UNITED STATES PATENT AND TRADEMARK OFFICE

APPLICATION NO.	FILING DATE	FIRST NAMED INVENTOR	ATTORNEY DOCKET NO.	CONFIRMATION NO.
10/645,035	08/21/2003	Michael E. Ring	CRD 01482	7356

Office Action Summary	Application No.		Applicant(s)	
	10/645,035		RING ET AL.	
	Examiner		Art Unit	
	Melody M. Burch		3657

DETAILED ACTION

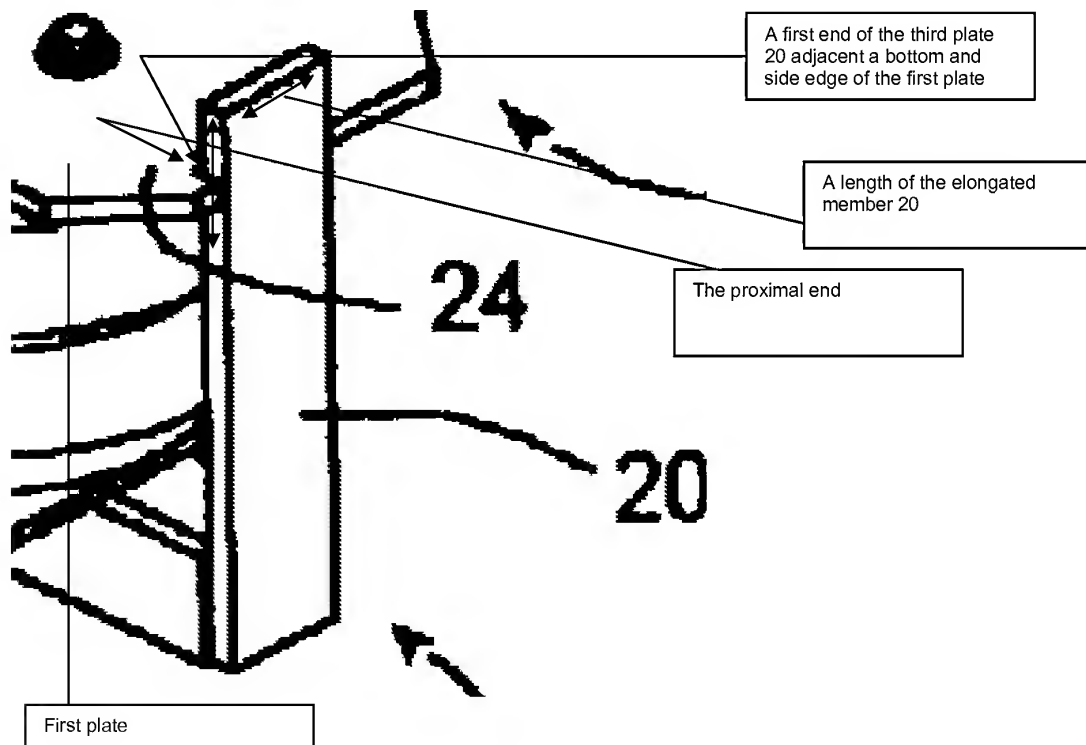
Re: claim 1. Johnson shows in figures 1 and 2 an actuating member capable of being used for a railway vehicle brake assembly, the vehicle brake assembly having an air spring actuator 1 incorporated therein, the air spring actuator having a pair of spaced apart end surfaces below 18(a) and above 18(b) and at least one inflatable air bag spring 3 defining an exterior peripheral surface of the air spring actuator, at least one of the pair of spaced apart end surfaces at least the top one having a plurality of mounting member extending outwardly therefrom as shown, said actuating member comprising: a first plate member 18(a) disposed substantially vertically with respect to element 20 during use of the brake assembly, the first plate member having a first

substantially planar surface thereof disposed in abutting relationship with one of the pair of spaced apart end surfaces of the air spring actuator as shown, the first plate member exposing the exterior peripheral surface of the at least one inflatable air spring to an atmospheric operating environment characterized by a presence of detrimental extraneous foreign material when the car mounted brake assembly is in use; a second plate member 20 disposed substantially horizontally with respect to 18(a) during use of the brake assembly, the second plate member directly attached to the first plate member at a bottom edge thereof and extending substantially perpendicular to the first substantially planar surface of the first plate member for shielding at least a first portion of the exterior peripheral surface of the air spring actuator from the detrimental extraneous foreign material; a structure 17,35 disposed on and attached to an opposed second surface of the first plate member for securing the actuating member to an actuating linkage of the brake assembly; a plurality of mounting apertures formed through a thickness of the first plate member as shown each of the plurality of mounting apertures operatively aligned with and sized to pass therethrough a perspective one of the plurality of mounting members extending outwardly from the one of the pair of end surfaces, a third plate member or other element 20 having a first end thereof disposed on the first substantially planar surface of the first plate member adjacent each of the bottom edge and a side edge thereof, the third plate member extending substantially perpendicular to the first plate member in close proximity to an inner surface of the second plate member as shown in the annotated figure on pg. 6.

As clearly shown in the annotated drawing on pg. 10 the third plate member or the other element 20 has a first end or the edge as labeled disposed on the surface of the first plate member adjacent both the bottom and side edge of the first plate member.

Examiner further notes that the third plate member extends perpendicularly to the first plate member in close proximity to an inner surface of the second plate member or the opposite element 20 shown in figure 2. Examiner notes that "close proximity" is a relative term. Examiner notes that third plate member is positioned in close proximity to the other element 20 as compared to its relative position with respect to element 25 shown in figure 2. Applicant does not clearly define "close proximity" in the specification or in the drawings. Figure 3 shows elements 64 and 76 but does not show a view that clearly sets forth what Applicant considers to be "close proximity". In *Rosemount Inc. v. Beckman Instruments Inc.* the court held that "close proximity" is as precise as the subject matter permits. *Rosemount Inc. v. Beckman Instruments Inc.*, 727 F.2d 1540, 221 USPQ 1, 7 (Fed. Cir. 1984). Since the subject matter fails to provide clear guidance, Examiner turned to Merriam Webster's Collegiate Dictionary 10th Edition which defines proximity as "the quality or state of being proximate: closeness." Since closeness is relative, Examiner maintains that one element 20 of Johnson is close to the other element 20 as compared to its position with respect to element 25 as shown in figure 2 of Johnson.
